CITY OF ALBUQUERQUE

**RE: MDS - Montage Subdivision Unit 7 on Bobby Foster
Grading and Drainage Submittal for Preliminary Plat and Grading Permit
Grading Plan Engineer's Stamp Date: 3/5/2023
Drainage Report Engineer's Stamp Date: 3/6/2023
Hydrology File: R16D100A**

**RE: MDS – Montage Subdivision Unit 7 on Bobby Foster
Grading and Drainage Submittal for Preliminary Plat and Grading Permit
Hydrology File: R16D100A**

Design Review Committee	City Engineer	Last Update	Mo./Day/Yr.	Mo./Day/Yr.
City Project No. 775685	Zone Map No. R-15-Z, S-15-Z	Sheet 1	Of 11

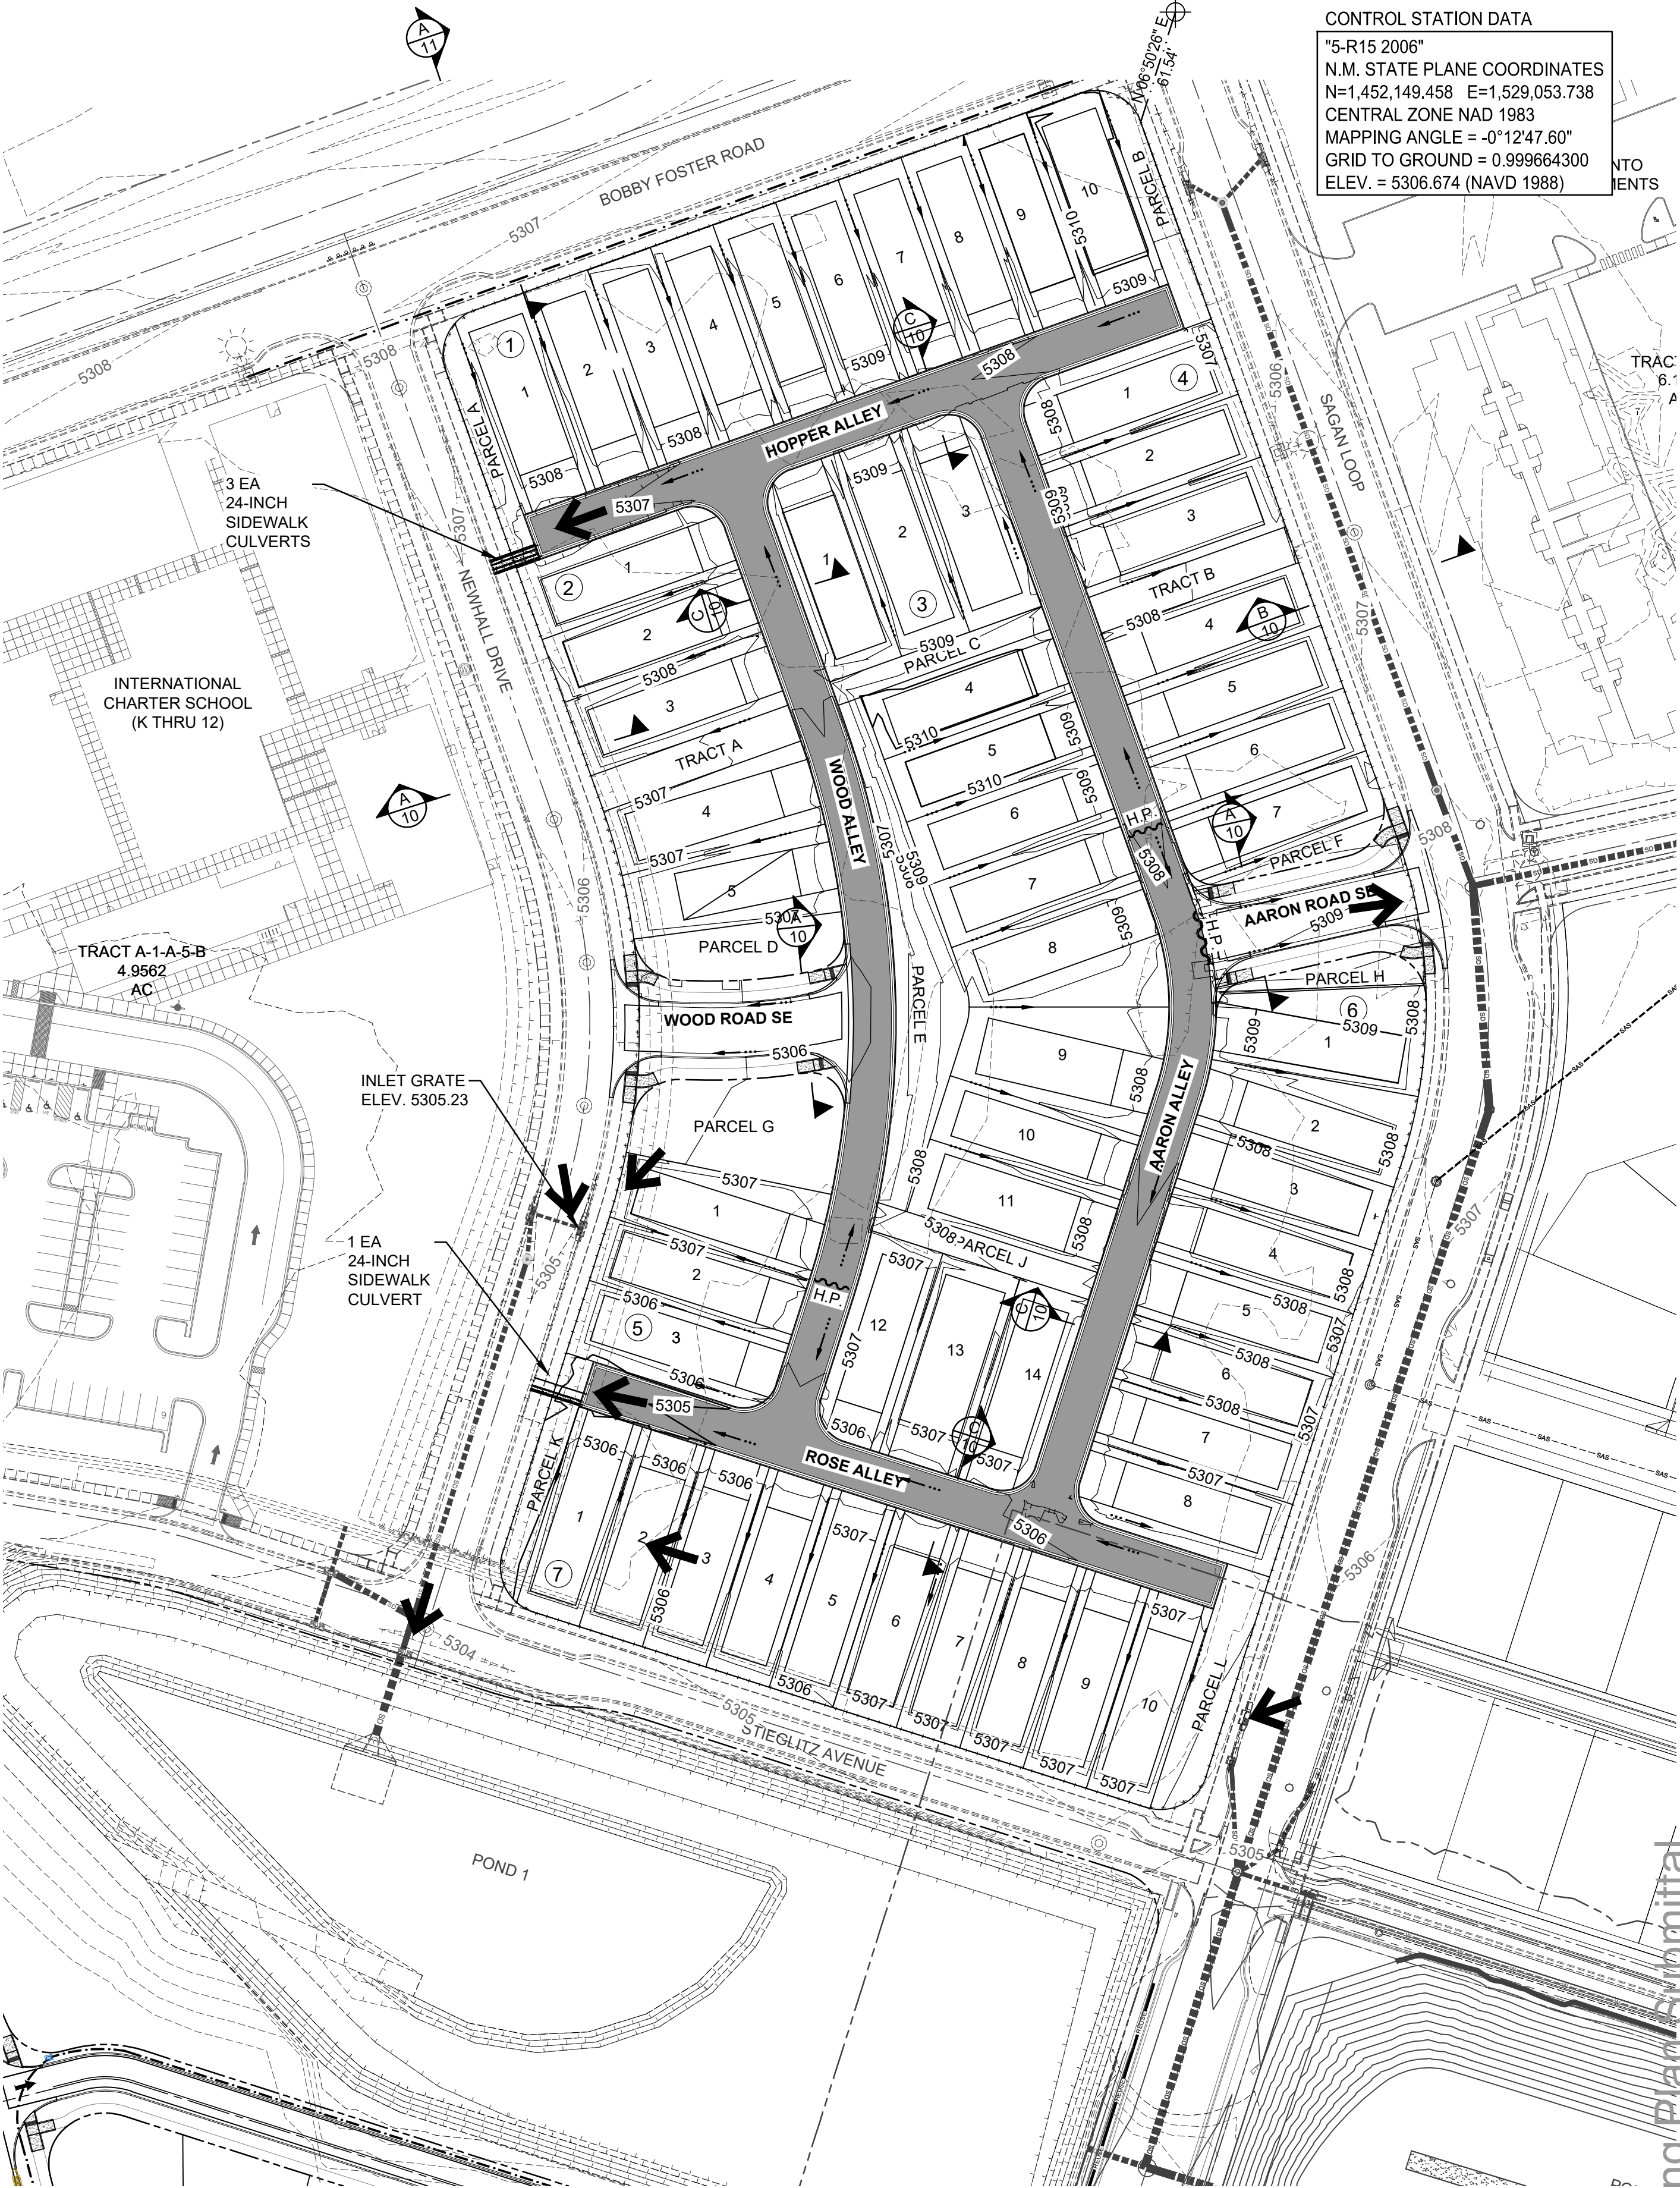
- a. Please provide the Benchmark information (location, description and elevation) for the survey contour information provided.
Benchmark information provided on sheet 1 – City Monument 5-R15.

- b. Please provide the FIRM Map number in a flood plain note with effective date.
Fema Map number 35001C0444H dated 8/16/2012 included on sheet 1. Site is within flood hazard zone X.

2. Add vicinity map and the Firm Map number in a flood plain note with effective date on the plan.

3. *Provide the Benchmark information (location, description and elevation) for the survey contour information provided.*

5. *Label "Pond 1" on the plan. Add drainage basins and alley names used in the drainage report on sheet 1.*

7. *Define "design 1" and "design 2" on sheet 1.*

Fema Map number 35001C0444H dated 8/16/2012 included on sheet 1. Site is within flood hazard zone X.

Benchmark information provided on sheet 1 – City Monument 5-R15.

Pond 1 is labeled on sheet 1 and Pond 2a is labeled on sheet 2. Alley names are updated on the revised sheets.

Reference to "design 1" and "design 2" removed from sheet 1.

Design Review Committee	City Engineer	Last Update	Mo./Day/Yr.	Mo./Day/Yr.
City Project No.	Zone Map No.	Sheet	Of	
775685	R-15-Z, S-15-Z	2	11

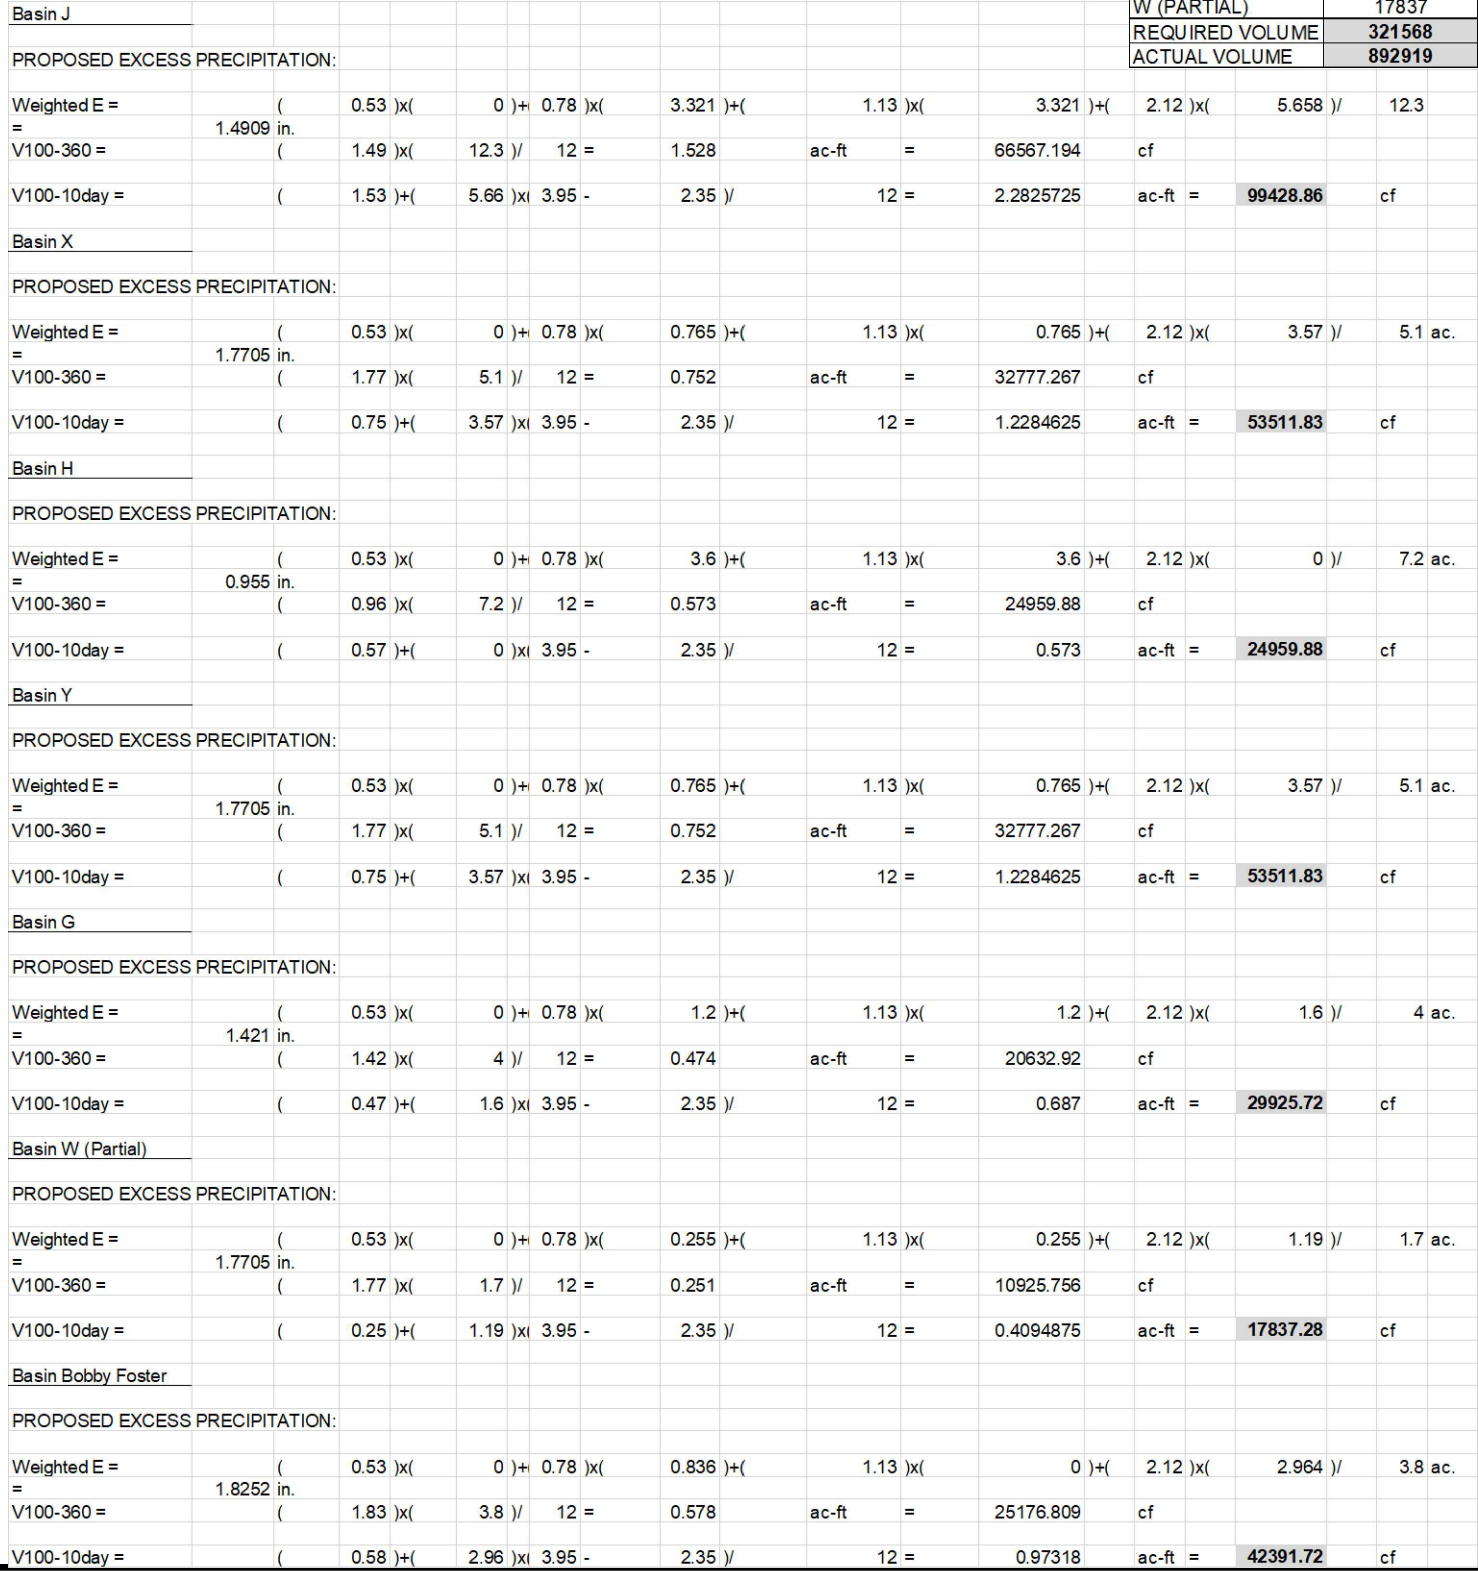
4. *Add a summary table showing the 100-yr, 10-day volume calculations and provided pond volume. Originally, pond 1 was anticipated to be constructed as a detention pond. It now proposes as a retention pond. Does it need to be upsized?*

1. *Neither this report nor the 2020 Bobby Foster Drainage Report has demonstrated adequate downstream capacity. Ponds 1 and 2A must be redesigned to retain the 100-year 10-day volume in accordance with the Montage Unit 3 & 4 Drainage Report with engineer's stamp date 1/18/2019. The 2020 Bobby Foster report and the 2011 Montage Units 1& 2 Drainage Reports both undersized the ponds by designing them as detention ponds rather than retention ponds.*

- a. *"A retention pond (pond 1?) exists south of Montage 7 and is designed to accommodate the runoff from the undeveloped site." - Please provide support documents for this statement. Originally, pond 1 was anticipated to be constructed as a detention pond, not a retention pond. (BP).*

Sheet 2 includes summary table showing the required volume and provided pond. No, the pond does not require upsizing.

Ponds 1 and 2a are redesigned to retain 100-year 10-day volume as shown on sheet 2.

Pond rating curve is included on sheet 2 and within the report.

Design Review Committee	City Engineer	Mo./Day/Yr.	Mo./Day/Yr.
City Project No.	Zone Map No.	Sheet	Of
775685	R-15-Z, S-15-Z	3	11

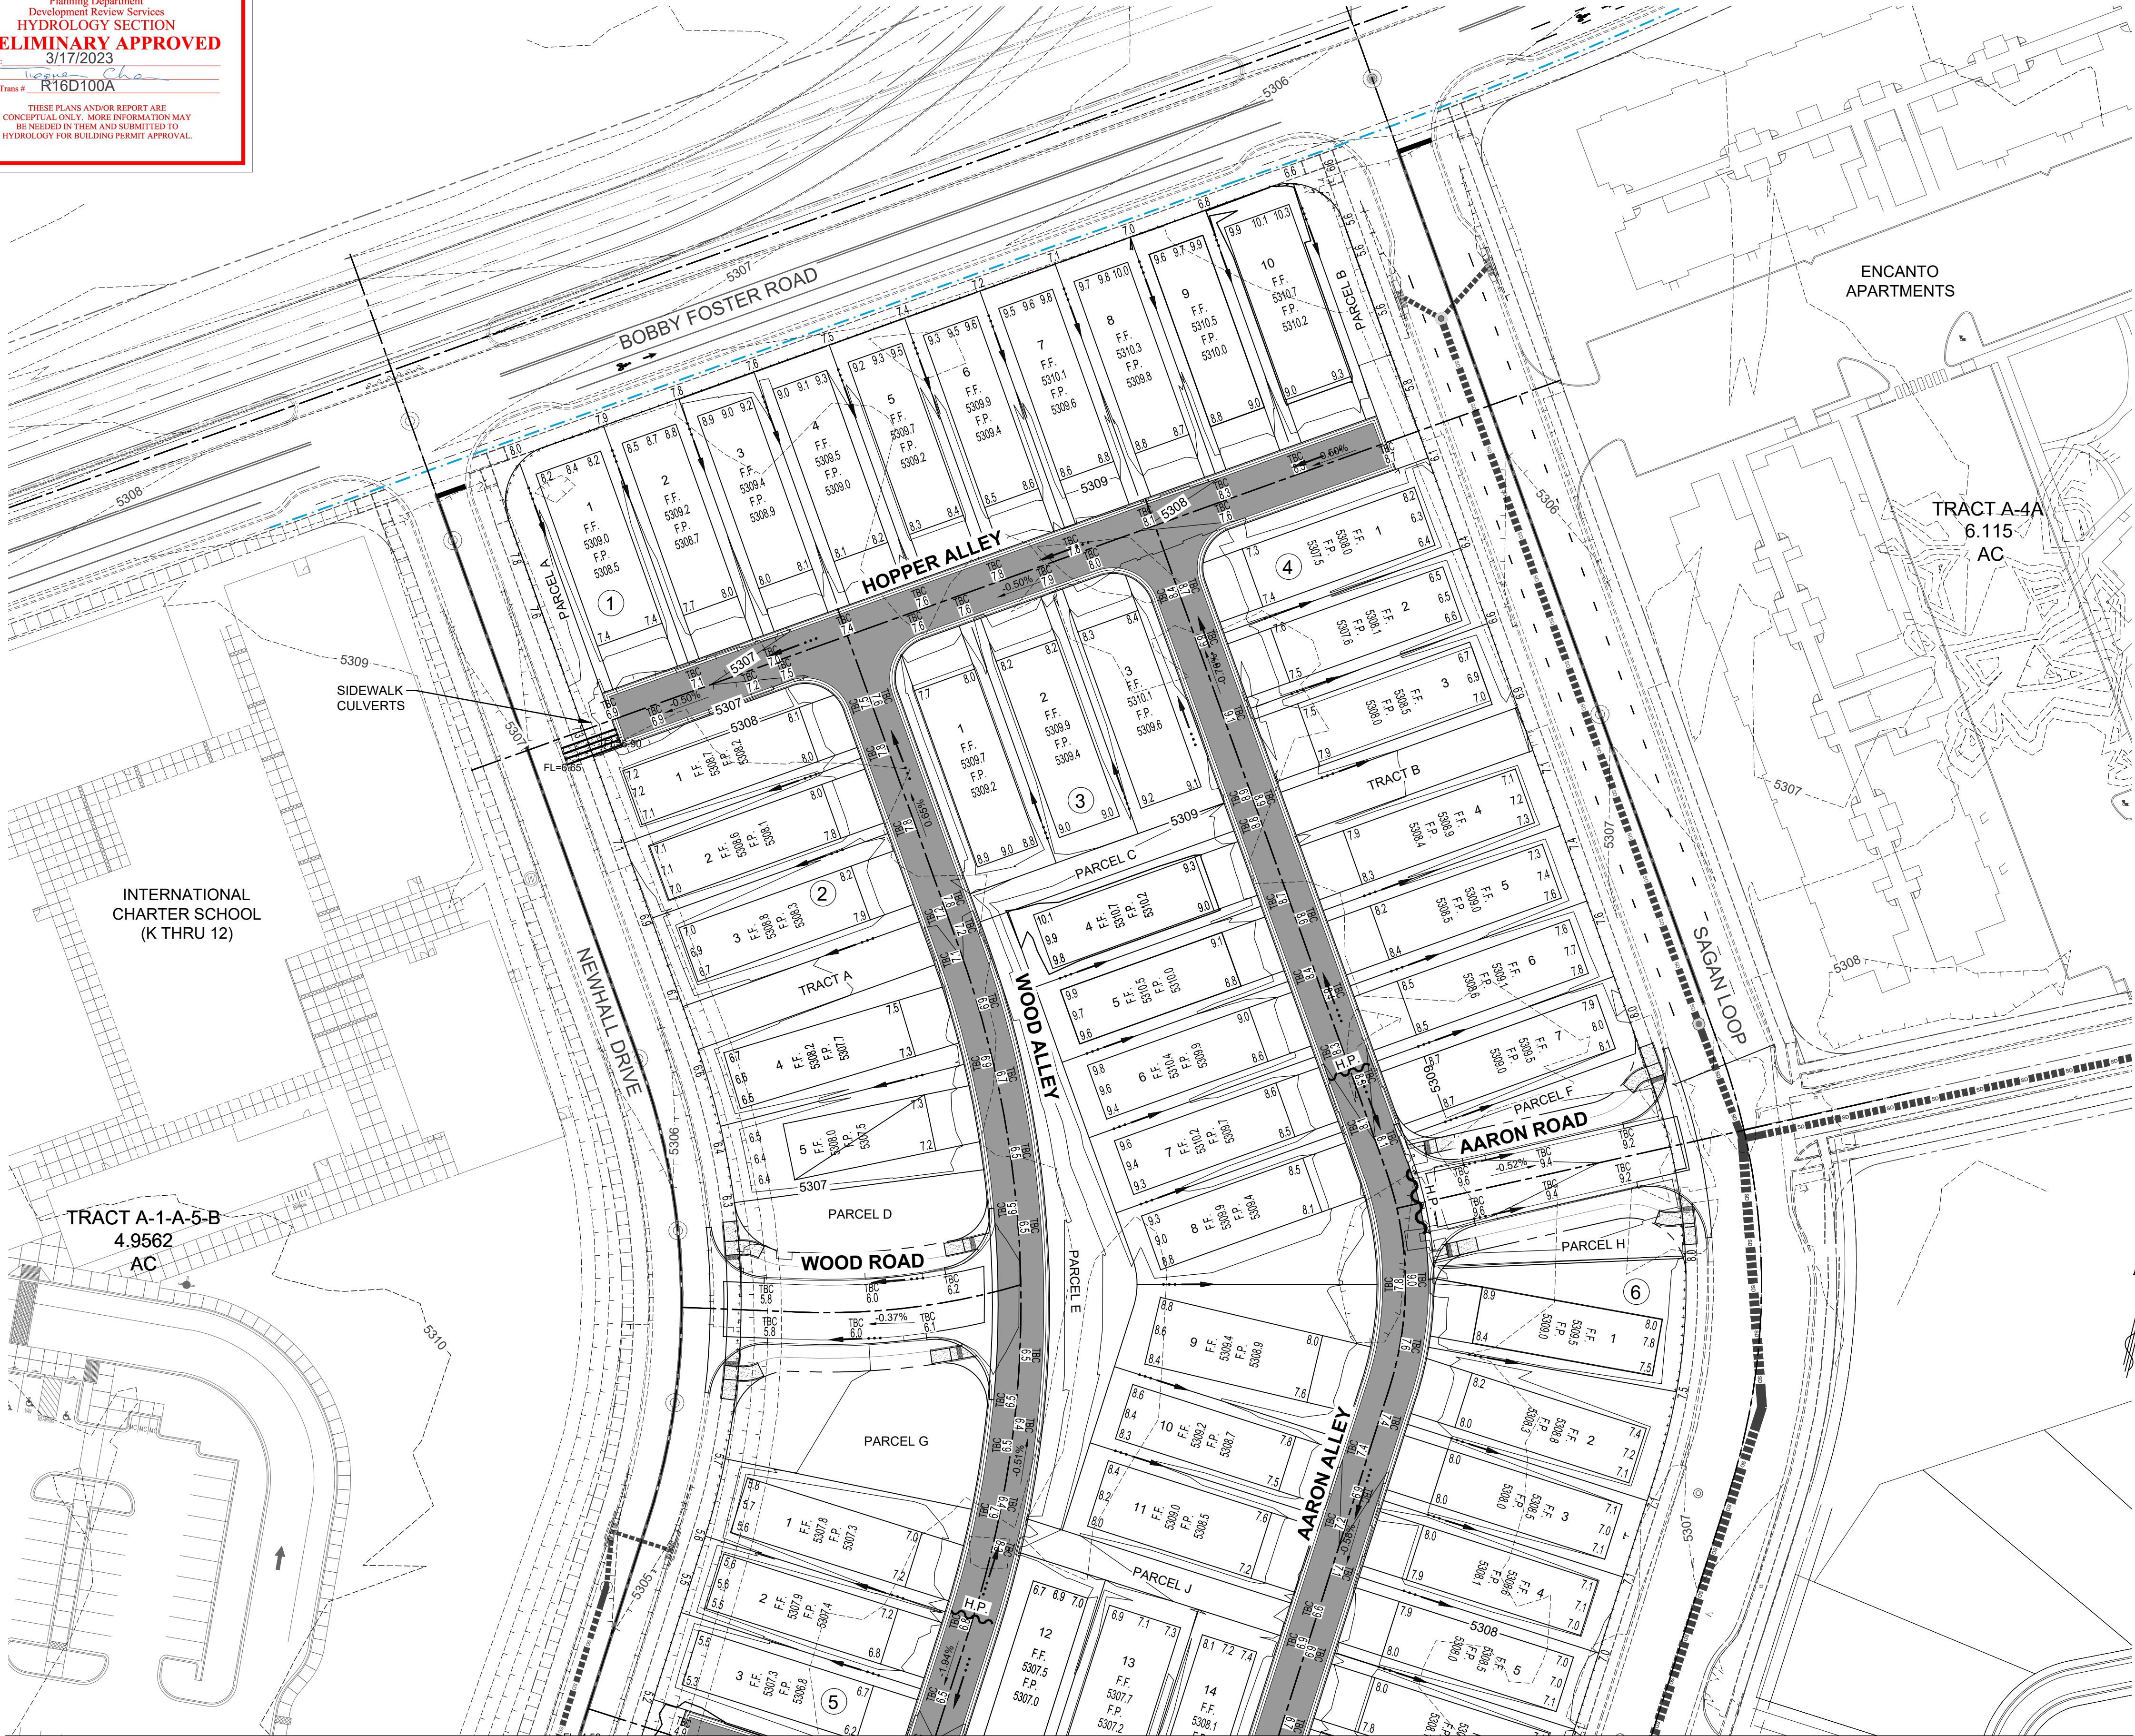
1. Add existing SD and proposed SD on to the legend.
2. Sheet 3, Hopper Alley to Newhall Drive: Add "3-24 inch" to the "Sidewalk Culverts" build note.
3. Sheet 4, Rose Alley to Newhall Drive: Add "1-24 inch" to the "Sidewalk Culvert" build note.
4. Add SO-19 notes. (Attached)
